Docket: Southern California Edison Company, San Onofre Nuclear Generating Station,
Units 2 and 3, Docket Nos. 50-361-CAL & 50-362-CAL

Re: Fourth Notification of Responses to RAIs

Subject: **Docket No. 50-361**
Response to Request for Additional Information (RAIs 2, 3, and 4)
Regarding Confirmatory Action Letter Response
(TAC No. ME 9727)
San Onofre Nuclear Generating Station, Unit 2

SOUTHERN CALIFORNIA EDISON
RESPONSE TO REQUEST FOR ADDITIONAL INFORMATION
REGARDING RESPONSE TO CONFIRMATORY ACTION LETTER

Figure 1 – Model for Estimating TTW Initiation Time

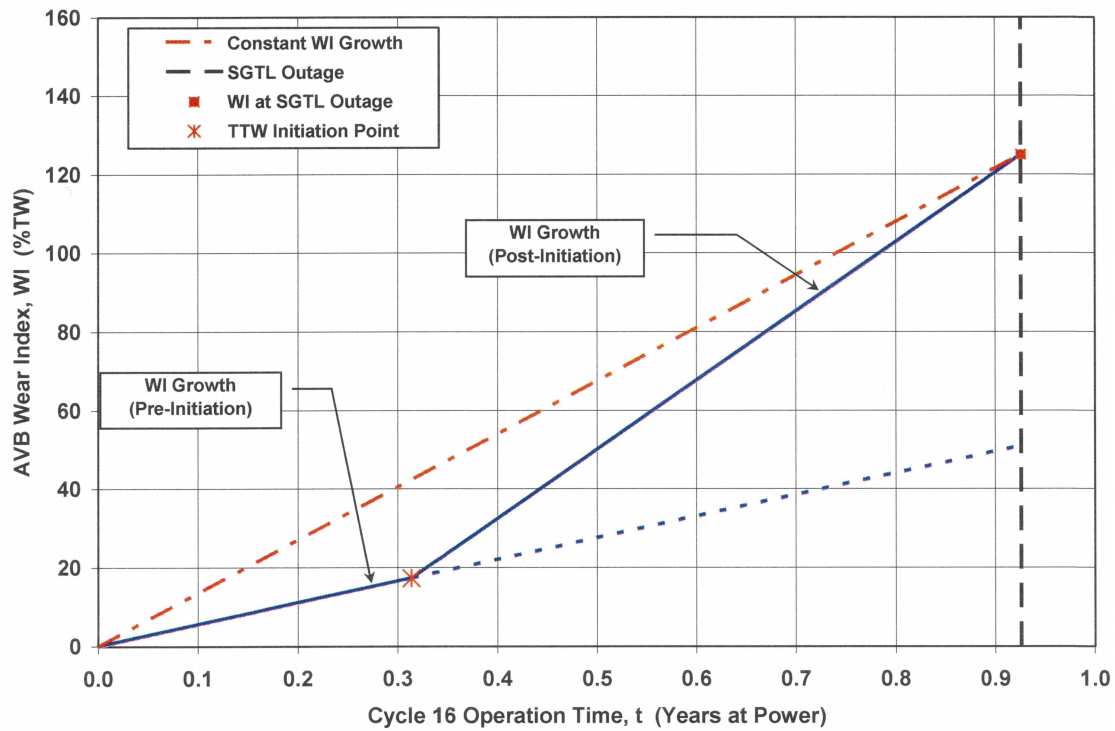
The Operational Assessment in Attachment 6, Appendix C (Reference 4), pages 3-2 and 4-12, appears to state that tube-to-tube wear (TTW) growth rates are based on the maximum TTW depths observed in Unit 3 at EOC 16 divided by the first Unit 3 operating period (0.926 years at power). Provide justification for the conservatism of this assumption. This justification should address the following:

- a. Reference 4, page 3-2 defines “wear index” for a degraded tube and states that the existence of TTW and distribution of TTW depths are strongly correlated to the wear index. This is pictured in Figures 4-4 in terms of TTW initiation. This figure shows that TTW is not expected to have initiated until a threshold value of wear index is reached. This threshold value varies from tube to tube according to a cumulative probability distribution shown in the figure. This figure illustrates that TTW is not expected to have initiated until sometime after BOC 16. This suggests that the observed TTW depth at EOC 16 developed over a smaller time interval than the 0.926 years assumed in the analysis.

To address the RAI question of TTW initiation time and the impact on the allowable inspection interval for Unit 2, additional analysis was performed. A time dependent predictive model (initiation-time model) for estimating the operating period prior to TTW initiation in Unit 3 was developed. This model is illustrated in Figure 1. This figure is a schematic example for a single tube where the rate of increase in the wear index is allowed to vary.

As shown in Figure 1, the growth in the wear index occurs in two stages: pre-initiation and post initiation. The initiation-time model for TTW uses a wear index based only on tube to AVB wear in the upper supports (B03 through B10). This model's wear index (WI) starts to increase at the beginning of the cycle. The basis for this approach was developed from the Unit 3 wear data as follows:

The predicted TTW initiation time is calculated by simulating two-stage growth in the WI. The initiation model is constrained to the end state for the calculated wear index from the NDE results. The slopes for the growth in the WI are also constrained to keep the two-stage process bounded by the constant WI growth case illustrated in Figure 1.

Figure 1 – Comparison of Initiation Models Based on Bobbin and +Point™ Wear Index Models

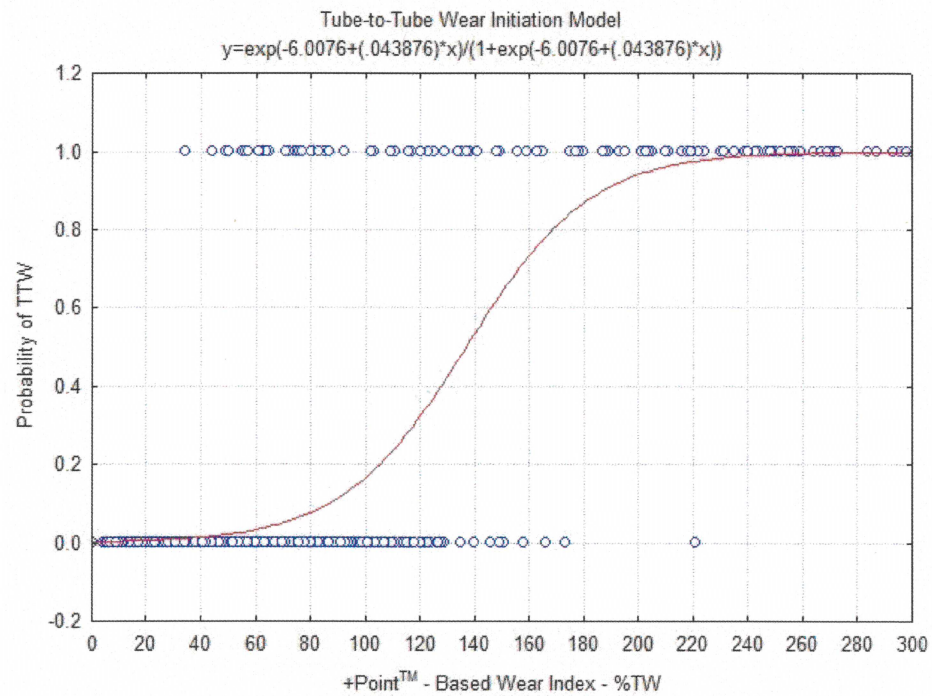
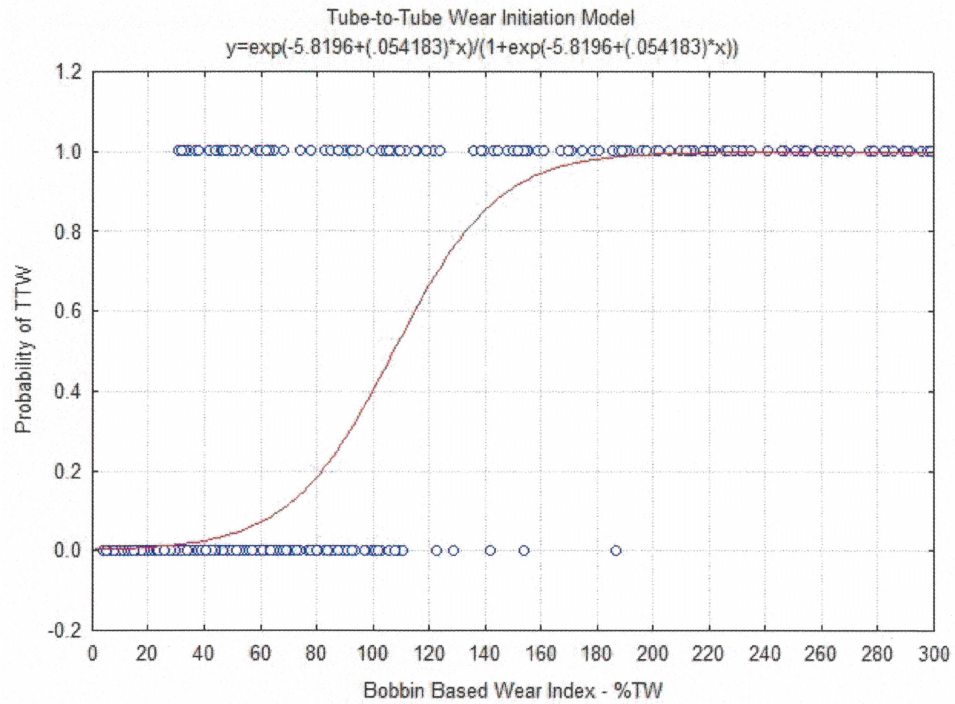
Regarding Reference 4, does the definition of “wear index” include summing the depths of 2-sided wear flaws at a given AVB intersection? If not, explain why SCE’s approach is conservative.

Bobbin and +Point™ based initiation models were developed using a logistic regression process. The resulting logistic functions are shown in Figure-1. The predictive ability of the two models was evaluated by simulating the TTW initiation process. This was accomplished by

presenting each function with its respective set of Unit 3 WIs and counting the predicted number of TTW occurrences. Both the bobbin-based and +Point™-based models produced similar (approximately 320 occurrences) results. This demonstrates that the incorporation of the +Point™-based WI doesn't improve the initiation model's ability to predict the presence of TTW. Since the Unit 2 initiation model was developed by benchmarking the Unit 3 model, there will be no improvement to the prediction of TTW initiation for Unit 2.
